August 29, 2022

RE: Docket Number EERE-2017-BT-STD-0009: Energy Conservation Standards for Walk-In Coolers and Freezers

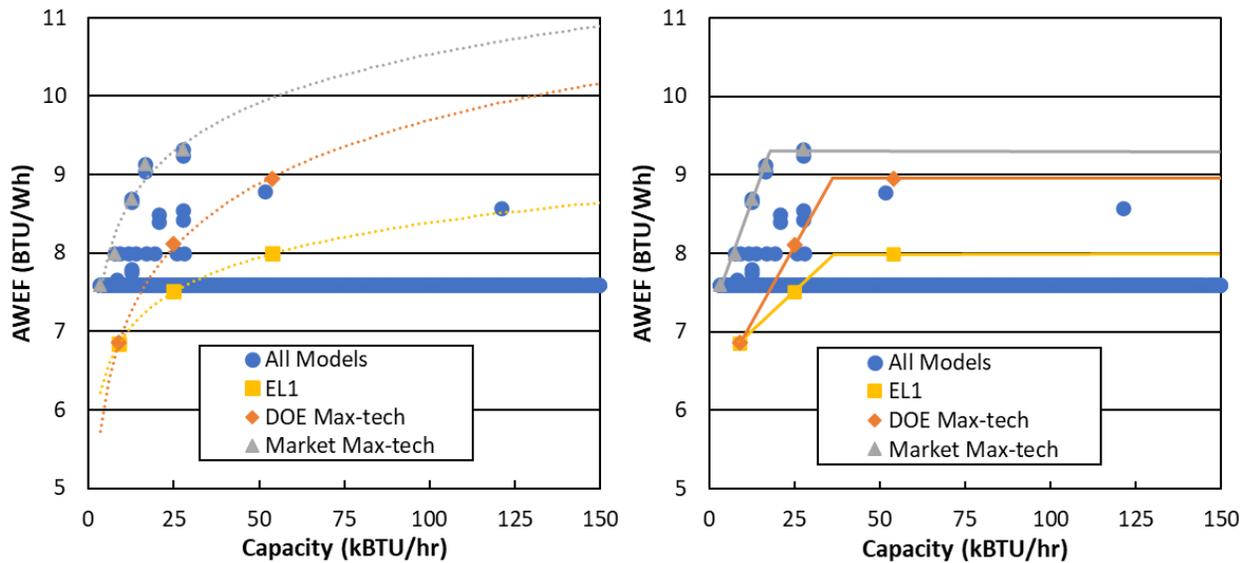
Finally, Figure 1 illustrates examples of how both a linear and logarithmic relationship could be used in setting potential ELs as a function of capacity. Figure 1 plots all models of medium-temperature outdoor DCUs (blue dots) in the Compliance Certification Database (CCD),⁷ the market max-tech level per the CCD database (gray triangles) as well as DOE’s max-tech (orange diamonds) and EL1 (yellow squares) levels. Figure 1 (left) shows how a logarithmic function could be used to set potential ELs as a function of capacity. Alternatively, Figure 1 (right) illustrates how ELs could be evaluated that are linear at lower capacities and constant above a certain capacity (i.e., analogous to the current standards for low-temperature DCUs and UCs). Either of these options would reflect our understanding that large-capacity refrigeration units are inherently more efficient. The plots in Figure 1 are meant as illustrative examples, as we understand that the DOE analysis and market AWEF values may not be directly comparable due to test procedure changes.

We encourage DOE to evaluate max-tech levels that are at least as high as the highest efficiencies available on the market. For various refrigeration equipment classes, including medium-temperature outdoor DCUs shown in Figure 1, there are models in the CCD with AWEF ratings exceeding DOE's max-tech level. While we understand that current ratings cannot be directly compared to the max-tech levels due to the proposed test procedure changes, these results suggest there could be models on the market that exceed DOE's max-tech level. We also note that there were even more efficient models in the CCD last fall, as highlighted in our previous request for information comments.¹⁴ Thus, we encourage DOE to ensure that the max-tech ELs are at least equivalent to the most efficient products on the market.
